NORWALK LA MIRADA UNIFIED SCHOOL DISTRICT
LA MIRADA HIGH SCHOOL NEW FOOTBALL
STADIUM PROJECT

ADDENDUM 1

FLOOR PLANS
BUILDING "W" -
MECHANICAL

M7.02

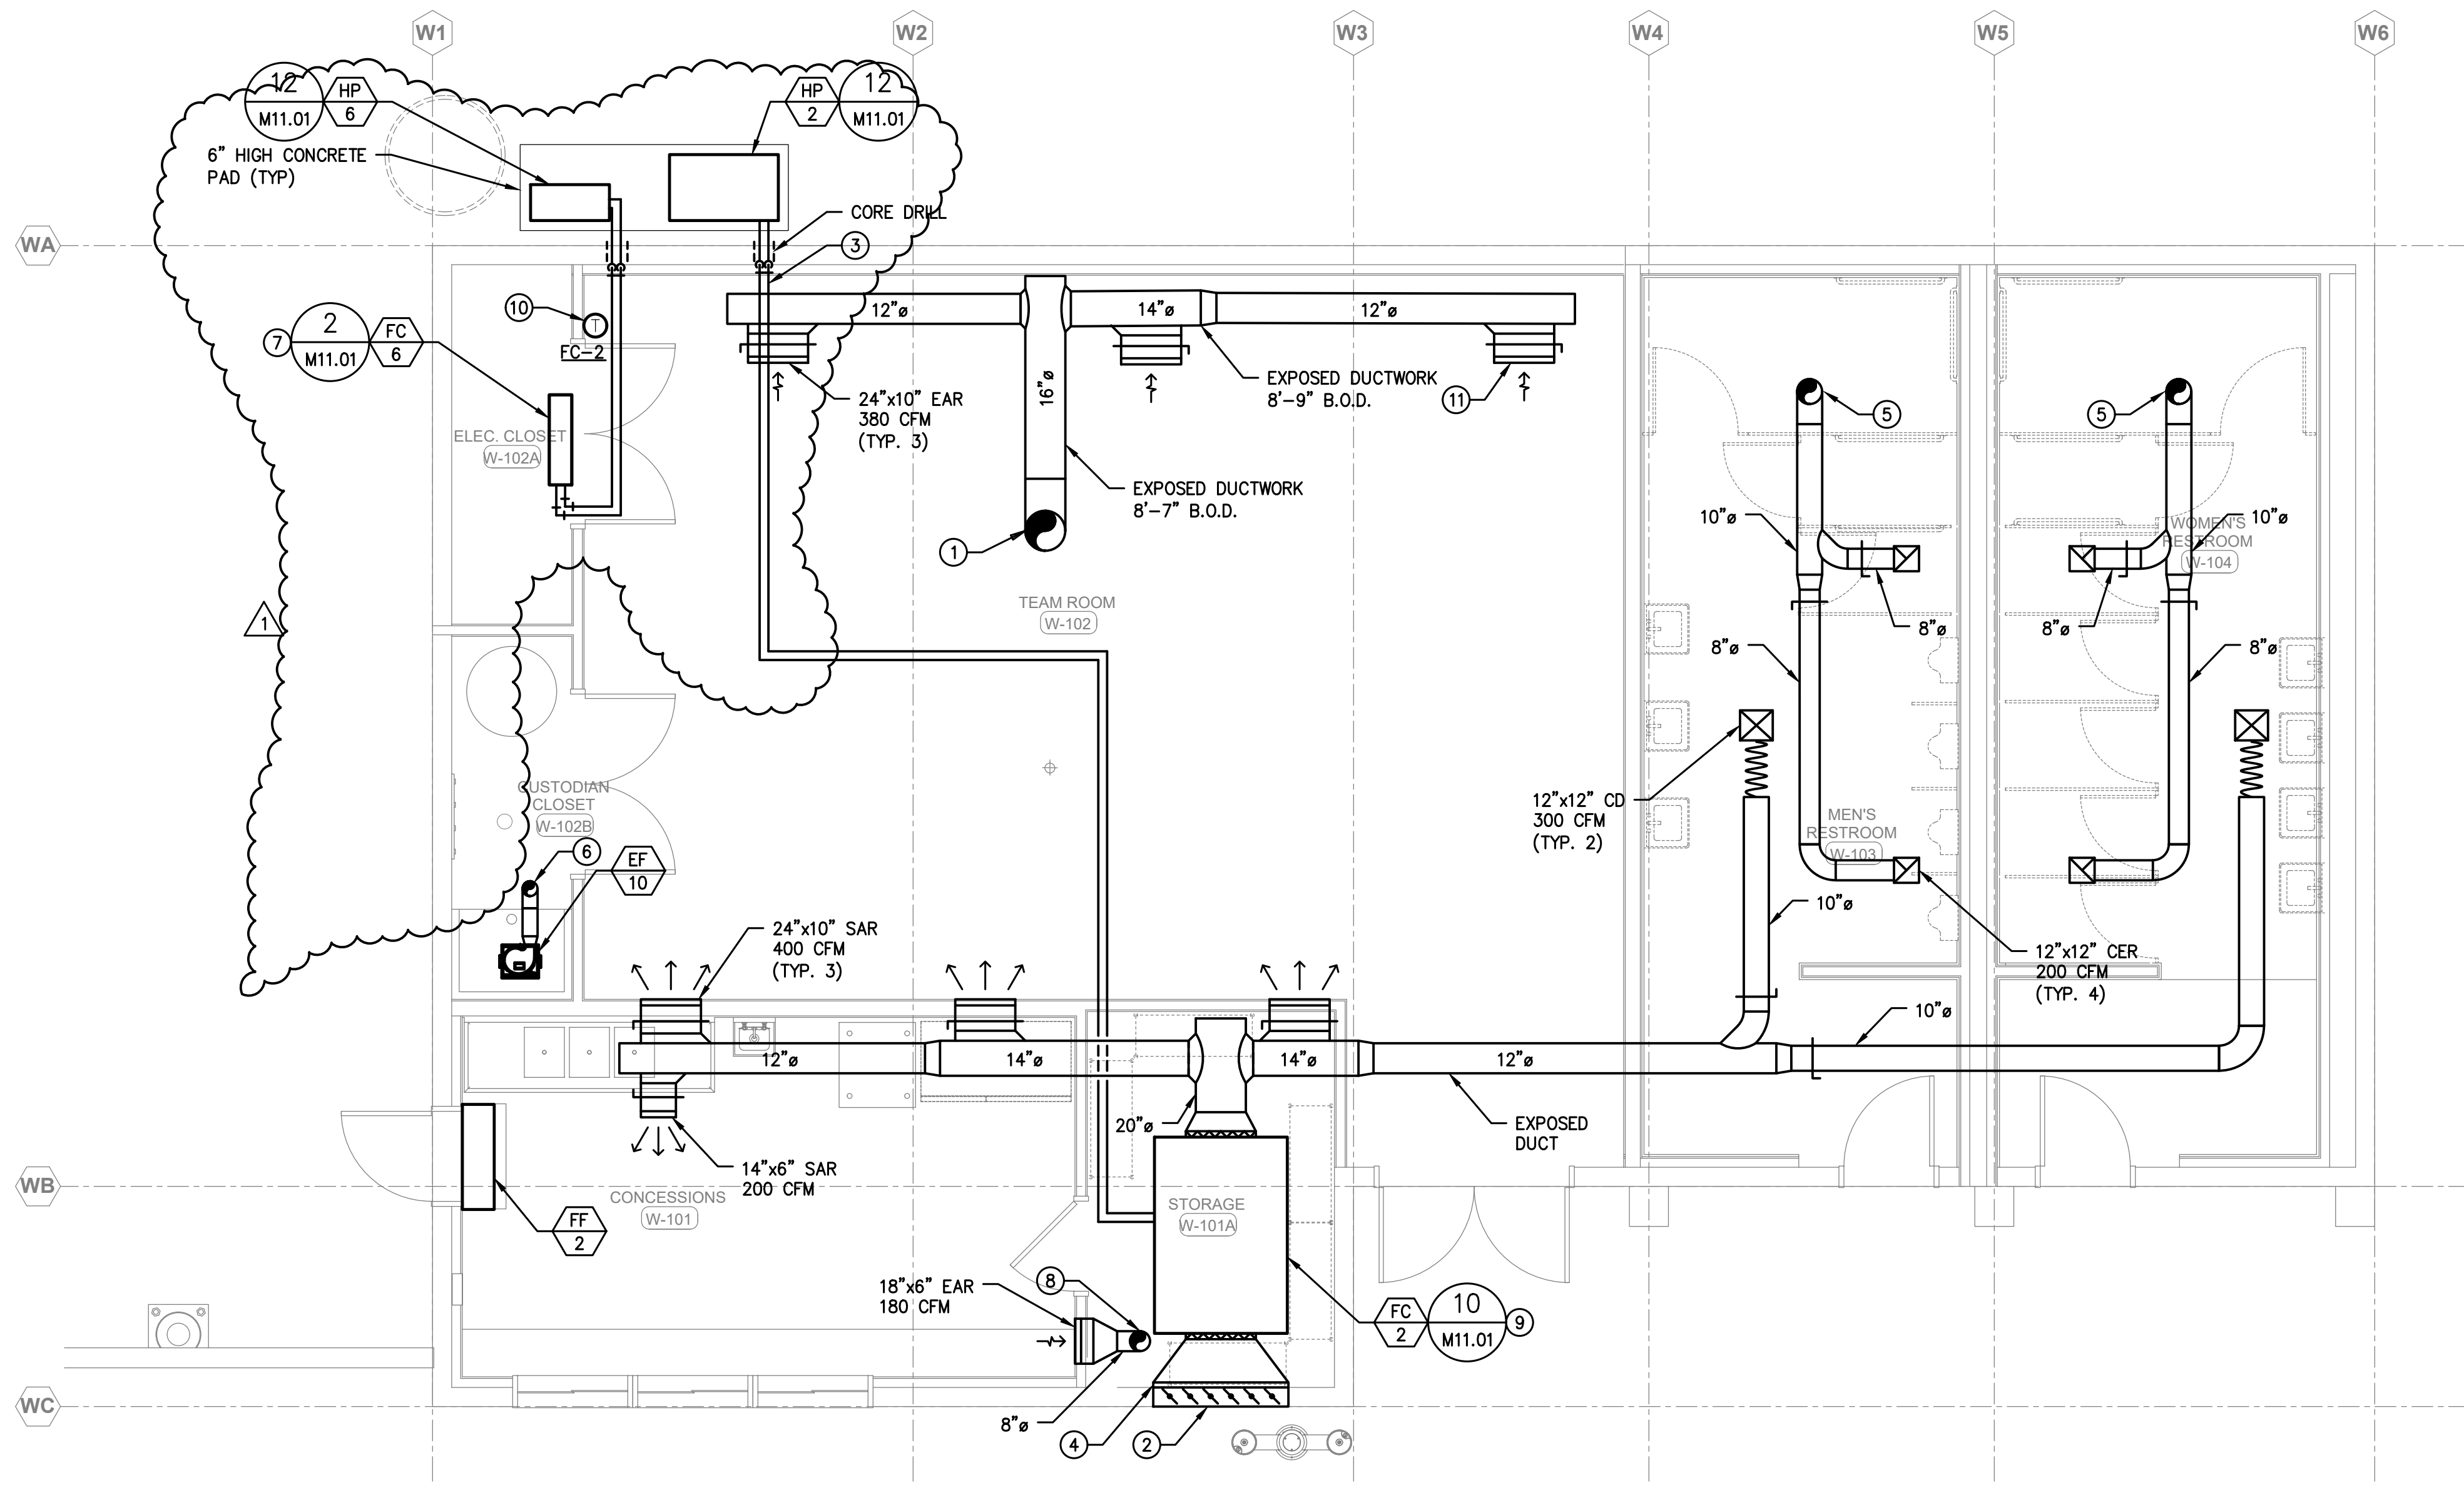
- 16" EXHAUST DUCT, TRANSITION AS REQUIRED UTR TO EXHAUST FAN.
- 36"X24" OSA LOUVER WITH BACKDRAFT DAMPER.
- REFRIGERATION LINES, BOTH INSULATED UP IN WALL. OFFSET AS HIGH AS POSSIBLE.
- PROVIDE 2" FILTER BOX WITH MERV-8 FILTER AT LOUVER OPENING. MATCH SIZE OF LOUVER.
- 10" EXHAUST DUCT TRANSITION AS REQUIRED UTR TO EXHAUST FAN.
- 6" EXHAUST DUCT UTR, TERMINATE WITH ROOF JACK.
- INSTALL FAN COIL UNIT ABOVE DOOR.
- 8" EXHAUST DUCT UTR.
- MOUNT FAN COIL AT 10'-0" ABOVE FINISHED FLOOR.
- PROVIDE NEW SCHNEIDER ELECTRIC SE 8000 SERIES THERMOSTAT. PROVIDE OVERRIDE BUTTON ON THERMOSTAT TO ALLOW "OFF-SCHEDULE" USE.
- MOUNT EXHAUST GRILLE ON CENTER LINE OF ATTACHED DUCTWORK. 8'-9" ABOVE FINISHED FLOOR.
